Watts Bar Nuclear Plant, Unit 1
Facility Operating License No. NPF-90
NRC Docket No. 50-390

Subject: Response to NRC Request for Additional Information Related to Application to Modify Watts Bar Nuclear Plant, Unit 1 Technical Specifications Regarding AC Sources - Operating (TS-WBN-13-02) (TAC No. MF2549)

ENCLOSURE
Watts Bar Nuclear Plant, Unit 1
Response to Request for Additional Information,
Offsite Power Availability Requirements

Figure 1

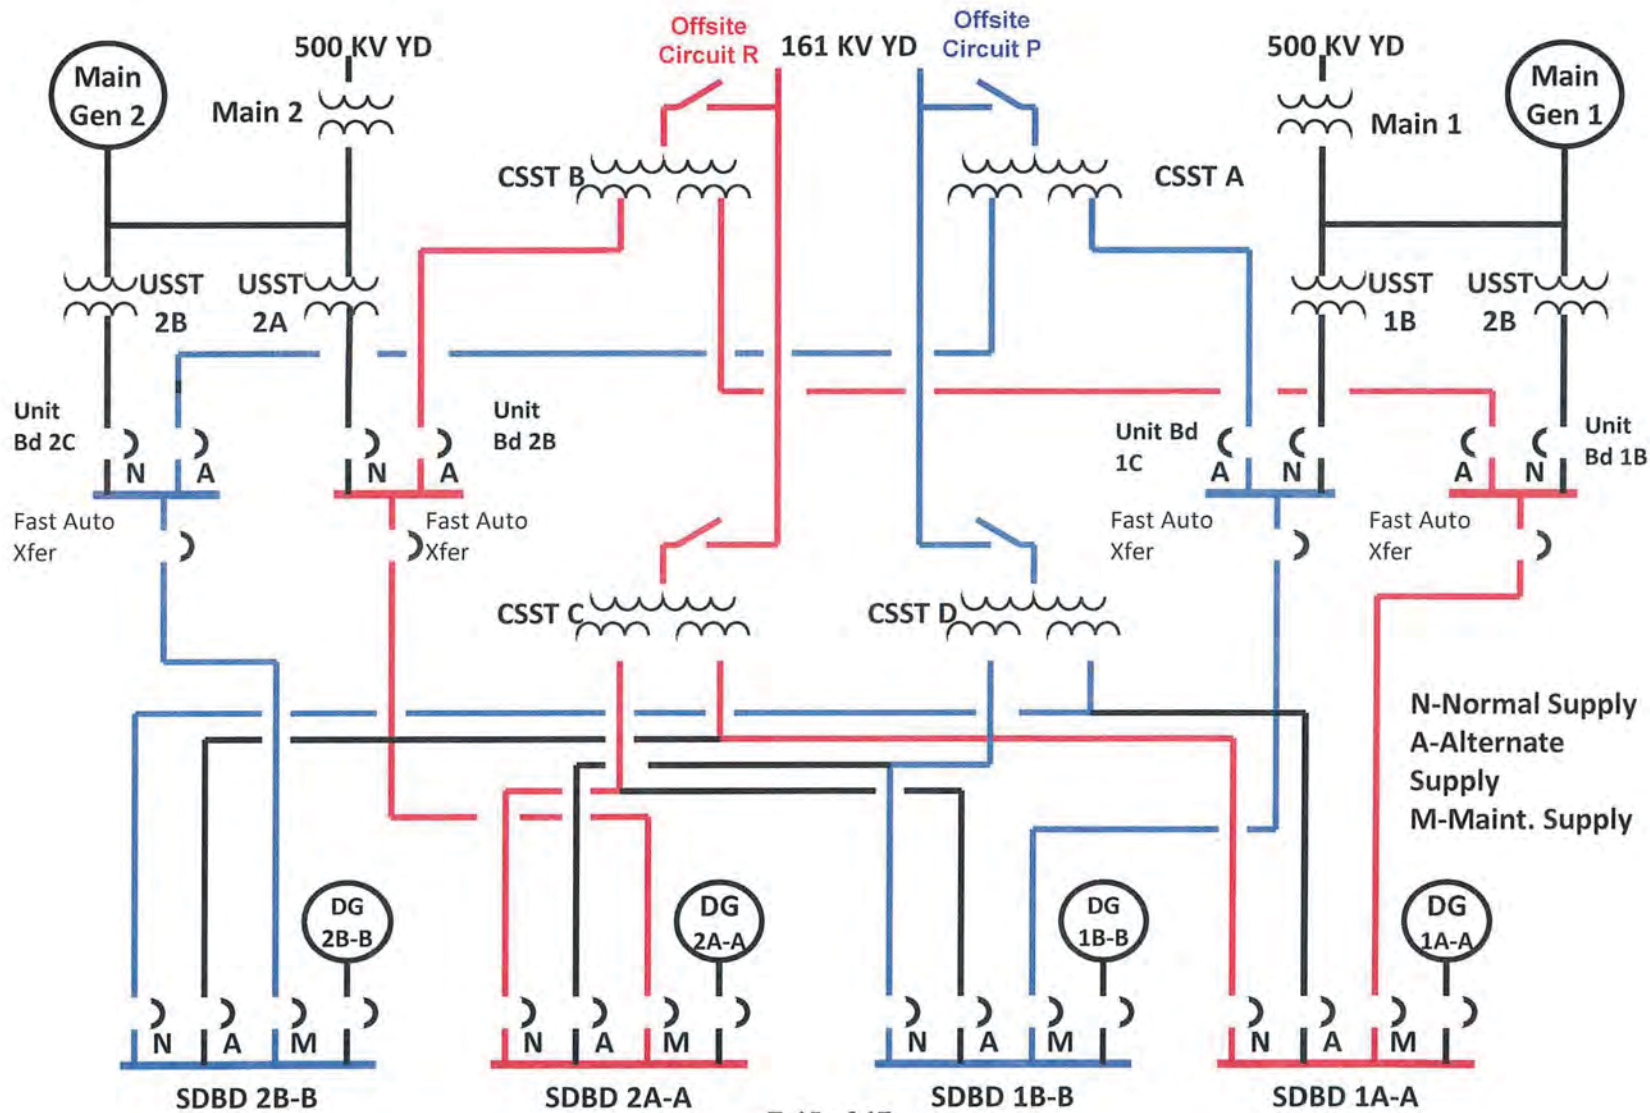
NRC RAI No. 2

In case of a LOOP event, the onsite power sources are required to connect to the safety busses. In order to recover from a LOOP or a station blackout (SBO) event, the offsite power sources have to be restored to the safety busses. The current TS surveillances validate the capability to parallel the onsite and offsite sources for successful transfer between the two sources through CSSTs C and D. To demonstrate operability of a power source, the licensee has to perform periodic surveillances in their required power source alignment to comply with the requirements of 10 CFR 50.36. The current TS proposal to use CSST A or B as GDC 17 sources does not appear to have TS surveillances to validate a similar capability. Please provide information on surveillances that will be performed to demonstrate the operability of the circuits between the switchyard and the safety busses through CSST A or B.

When all 6.9 kV shutdown boards are aligned to their normal source, or all 6.9 kV shutdown boards are aligned to their alternate source, the automatic transfer to the alternate source is not required to comply with GDC 17. See Figure 1 below for the following discussion. More specifically, under the alignment when each of the shutdown boards is supplied from its normal source (Shutdown Boards 1A-A and 2A-A supplied from CSST C and Shutdown Boards 1B-B and 2B-B supplied from CSST D), each of the circuits (P and R) are available in sufficient time (i.e., immediately) following a loss of all onsite alternating current (AC) power supplies and the other offsite electric power circuit, to assure that specified fuel design limits and design conditions of the reactor coolant pressure boundary are not exceeded. In addition, under that same alignment, each of these circuits (P and R) is available within a few seconds (i.e., immediately) following a loss-of-coolant accident (LOCA) to assure that core cooling, containment integrity, and other vital safety functions are maintained.

Similarly, when all shutdown boards are aligned to their alternate source (Shutdown Boards 1A-A and 2A-A supplied from CSST D and Shutdown Boards 1B-B and 2B-B supplied from CSST C) each of the circuits (P and R) are available in sufficient time (i.e., immediately) following a loss of all onsite AC power supplies and the other offsite electric power circuit to assure that specified fuel design limits and design conditions of the reactor coolant pressure boundary are not exceeded. In addition, under that same alignment, each of these circuits (P and R) is available within a few seconds (i.e., immediately) following a LOCA to assure that core cooling, containment integrity, and other vital safety functions are maintained. Under these alignments (all aligned to normal or all aligned to alternate) the normal-to-alternate fast transfer is not required to comply with GDC 17.
